**RIVERSIDE DRIVE AT 8<sup>TH</sup> AVENUE IMPROVEMENTS**

April 14, 2009

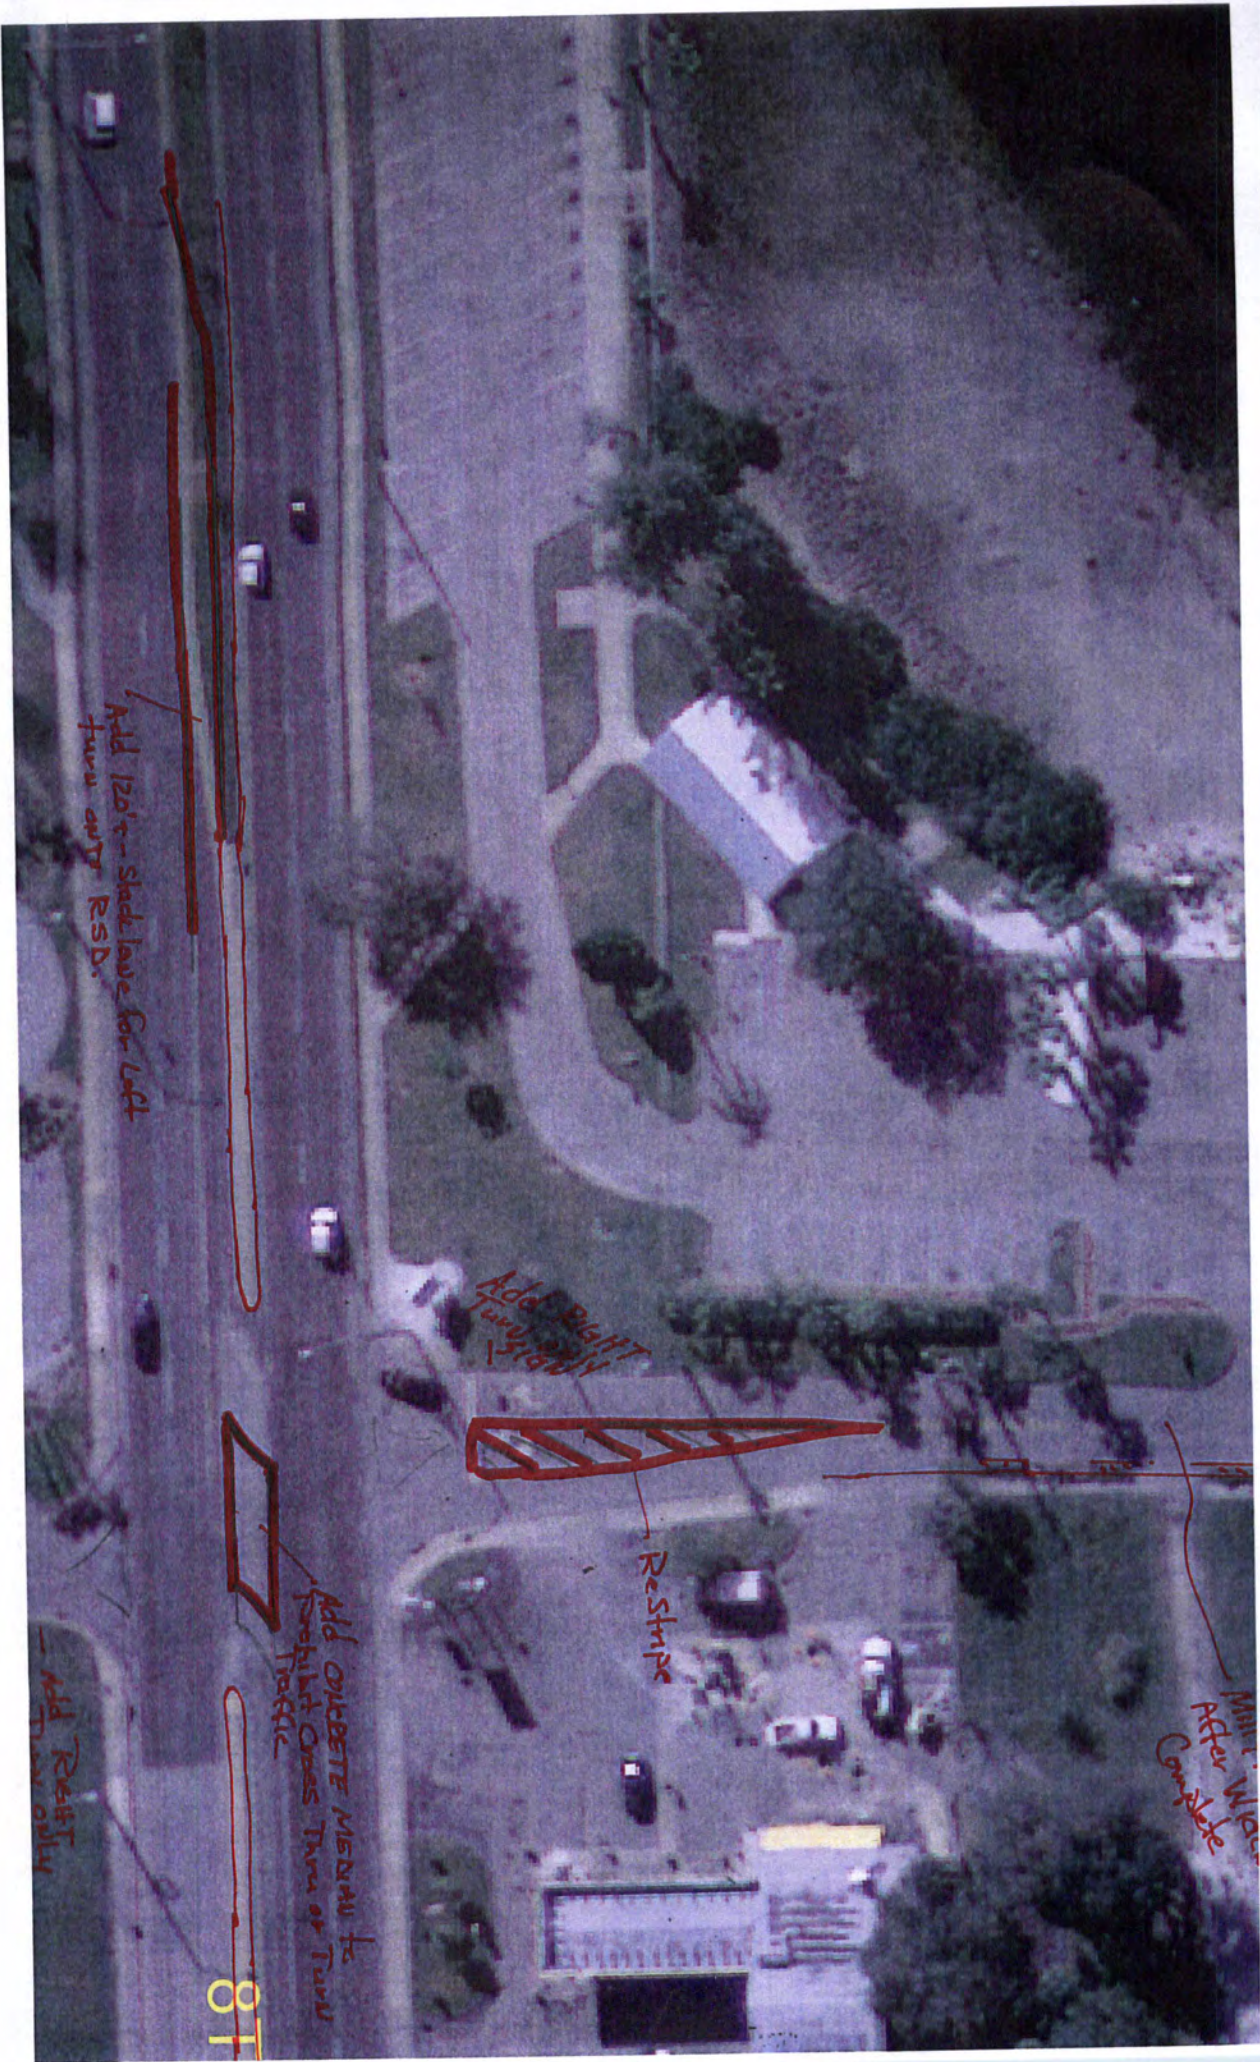
Add 120' + - shoulder for left turn only RSD.

Add Right Turn Lane

Re-Stripe

Add CONCRETE MEDIAN to prohibit Cross Thru or Turn Traffic

Mill & Patch After Complete
